Providence City Plan Commission

November 16, 2021

AGENDA ITEM 2 ■ 663 ADMIRAL STREET

PROJECT OVERVIEW

1 FIRST FLOOR PLAN
SK1.0 1/8"=1'-0"

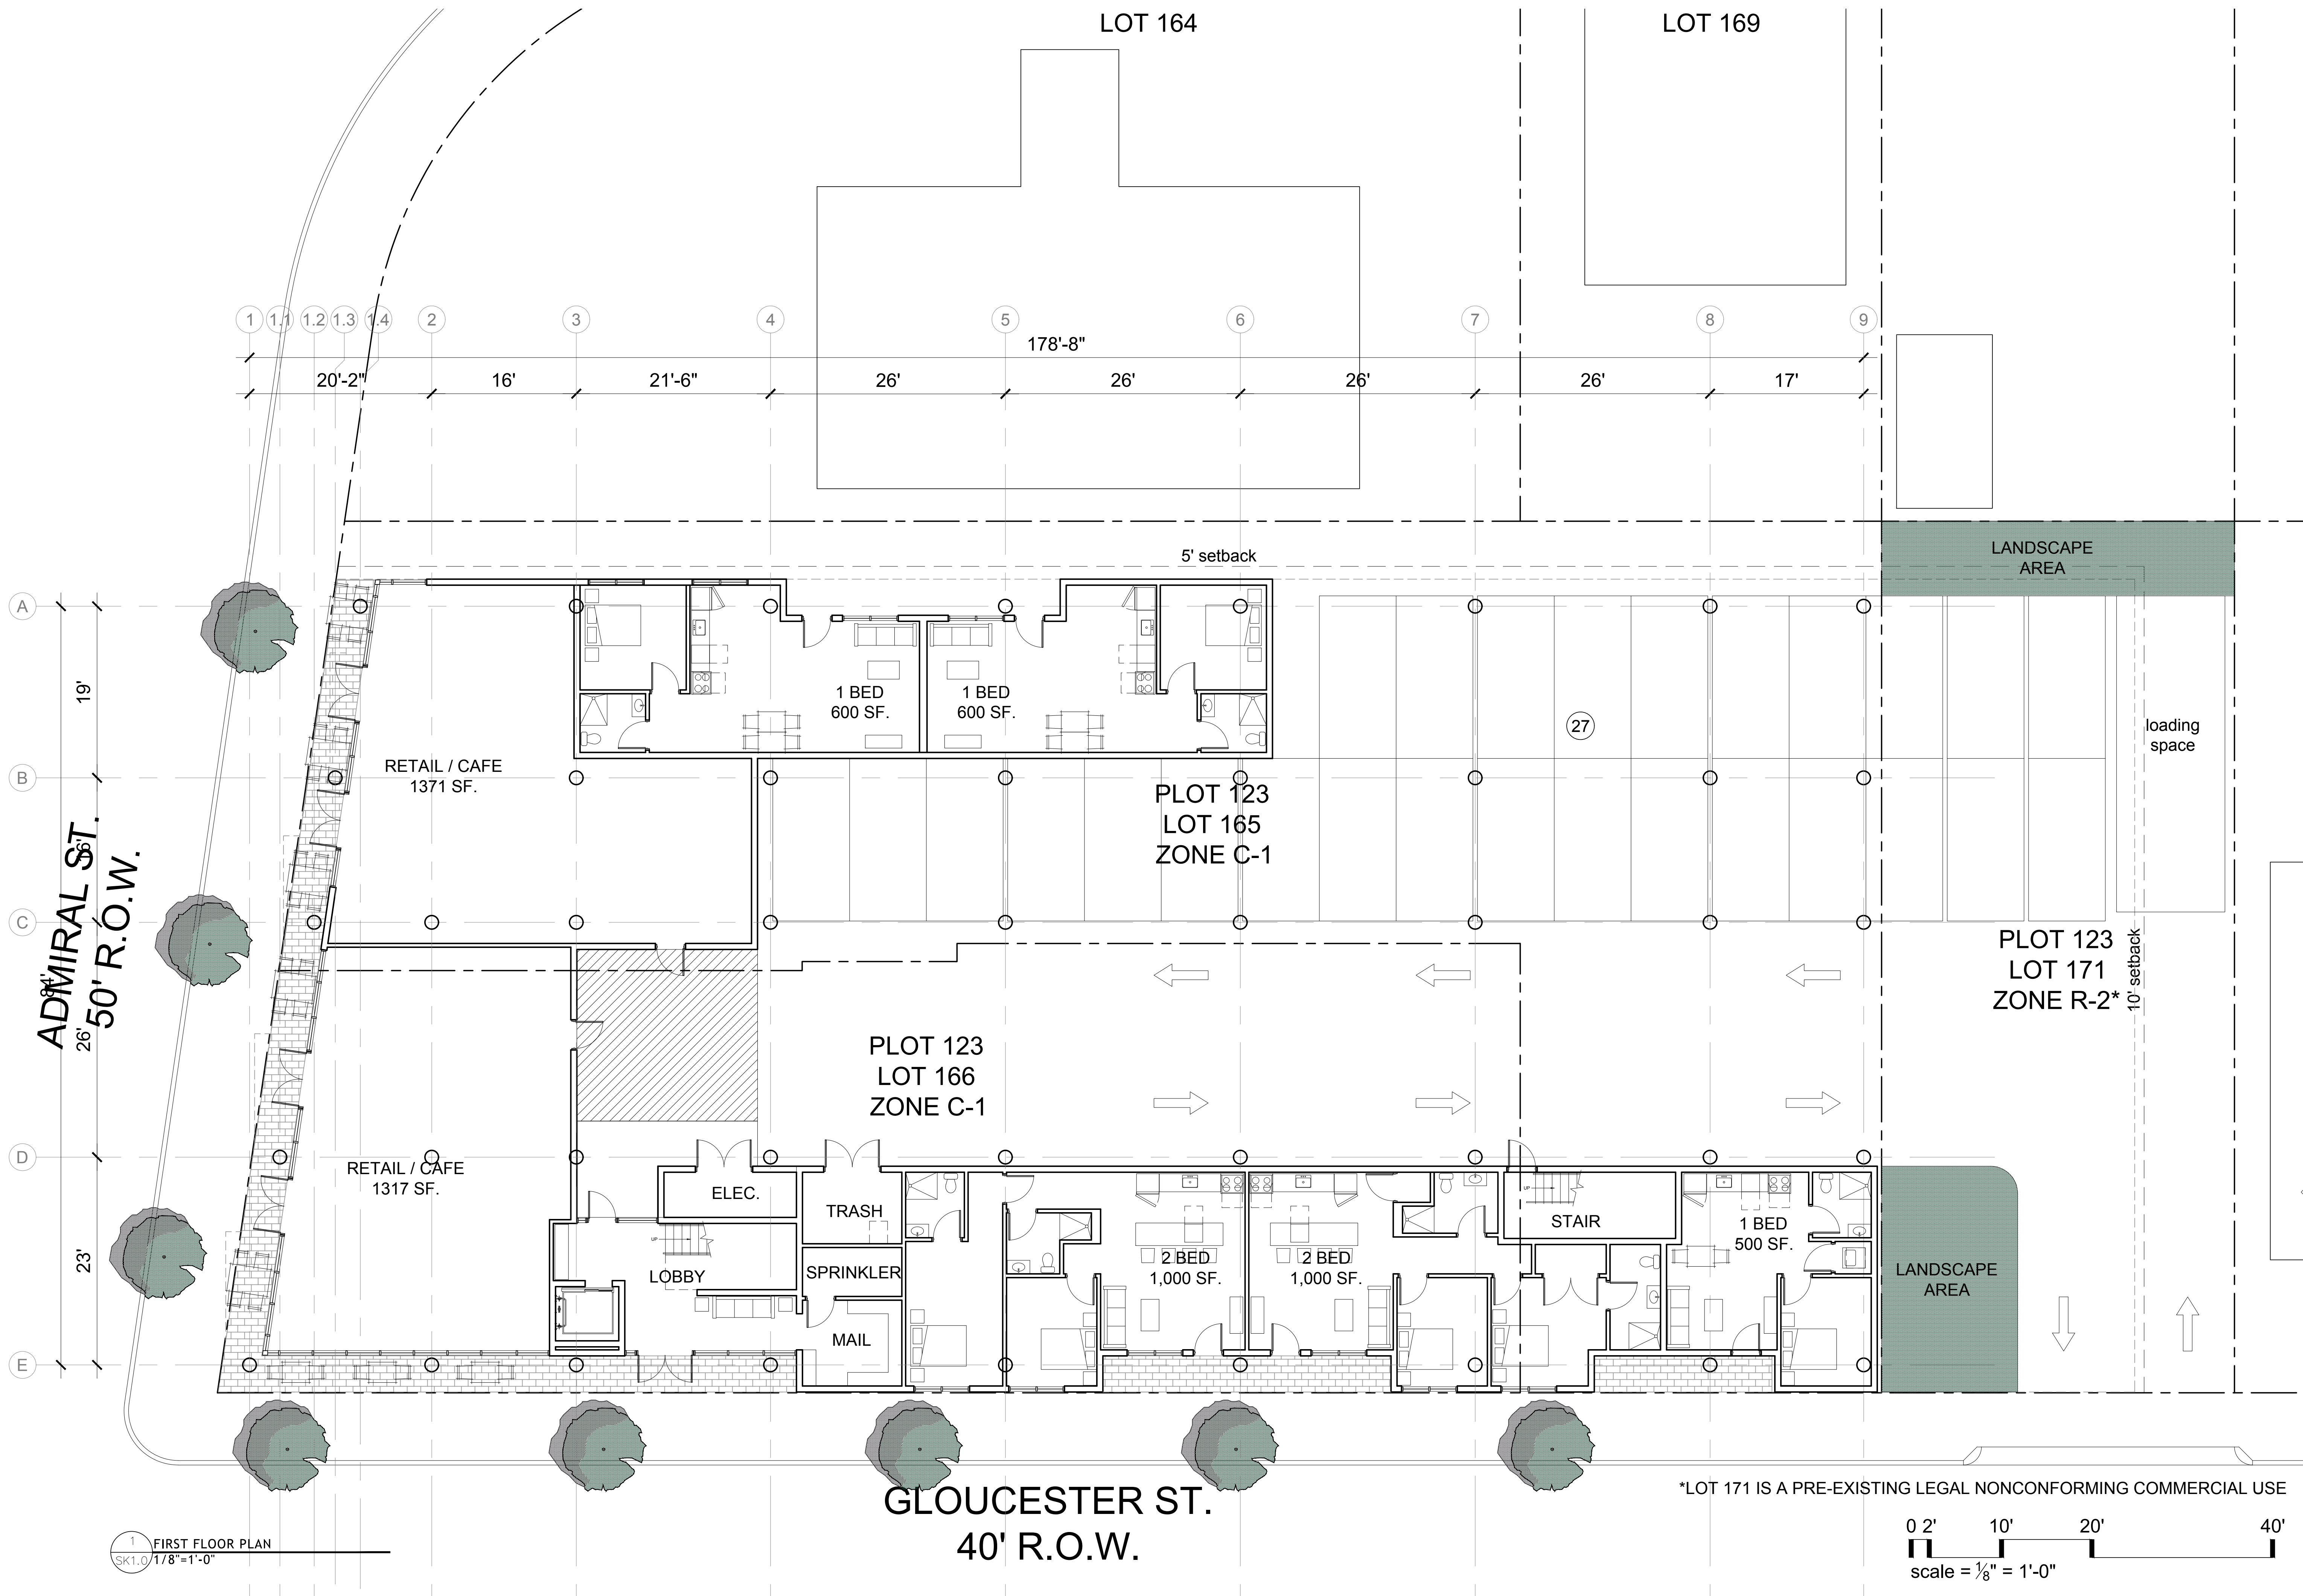
The parking area, which consists of fifteen rows of tandem parking and two single spaces will be accessed from Gloucester Street. Forty three spaces are required for the residential and commercial uses and a dimensional adjustment is being requested for the deficit of 11 spaces. The applicant should demonstrate how the parking arrangement would allow for circulation within the parking area and how residents that are parked internally in a tandem spot would access vehicles when required. In requesting the waiver, the applicant should also provide more information on measures that will be taken to reduce reliance on onstreet parking by residents that will not have assigned parking spaces.

applicant providing more information on operation of the parking arrangement. More information on how owners would access and move vehicles parked in tandem and reducing reliance on onstreet parking should be provided. The plan should also indicate the drive aisle width. The CPC should consider the adjustment subject to the applicant providing the requested information.

Landscaping: A conceptual landscaping plan has been submitted showing street trees and landscaping areas to be installed around the site. As discussed, it is unclear if the area under lot 171 will meet the 65% impervious coverage limit with the presence of the transformer. A detailed landscaping plan which shall be subject to the Forester's approval is required at the preliminary plan stage.

1. A parking adjustment is required to approve the master plan. The CPC should only act on the adjustment upon the applicant providing more information on circulation, vehicle access, management of the parking area and reducing reliance on onstreet parking around the site. The plan should also be updated to include the width of the drive aisle.
2. The applicant should provide plans for management of resident behavior and curbing the effects of students on neighboring property.
3. The impervious surface calculation should account for the presence of the transformer in the planting area.
